Process Sheet

Customer : CU-DAR001 Dart Helicopters Services	Drawing Name : PLUG
Job Number : 44063	
Estimate Number : 13093	
P.O. Number :	Part Number : D3492053
This Issue : 12/12/2008 S.O. No. :	Drawing Number : D3492 REV C
Prsht Rev. : NC	Project Number : N/A
First Issue : / / Type : MACHINED PARTS	Drawing Revision : C
Previous Run : 40357	Material :
Written By :	Due Date : 19/12/2008 Qty: 30 Um: Each
Checked & Approved By : <u>JUD 08.12.12.</u>	
Comment : Est Rev:A New Issue 06-06-20 JLM Est Rev:B as per Rev C 07-12-06 DD verified by:EC

DRAWING NO. D3492	TITLE PLUG	REV. C	DART AEROSPACE LTD ENGINEERING ORDER		D.E.O. NO. D3492-C-1	SHEET NO. SHEET 1 OF 1	SCALE NTS
DRAWN AJS	CHECKED <i>[Signature]</i>	MFG. APPR. <i>[Signature]</i>	APPROVED <i>[Signature]</i>		DE APPR. <i>[Signature]</i>		
DATE 08.11.05	DATE 08.11.05	DATE 08.11.05	DATE 08/11/05		DATE 08/11/05

D3492-XX PLUG MACHINING DETAILS

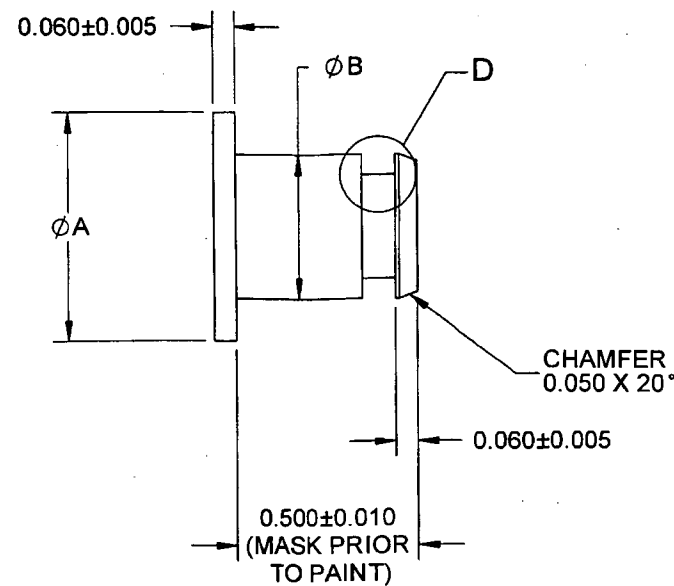
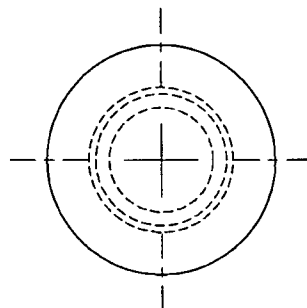
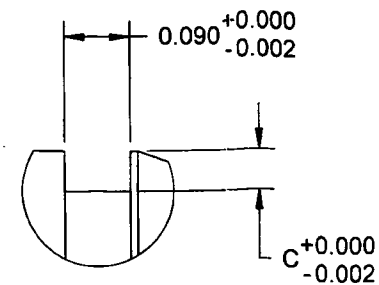
SHEET 2 MODIFY -13 PLUG AS SHOWN:

IS:

P/N	A	B	C	MATERIAL SPEC
D3492-13	0.750	0.510	0.045	M6061T6R0.750

WAS:

P/N	A	B	C	MATERIAL SPEC
D3492-13	0.750	0.520	0.045	M6061T6R0.750
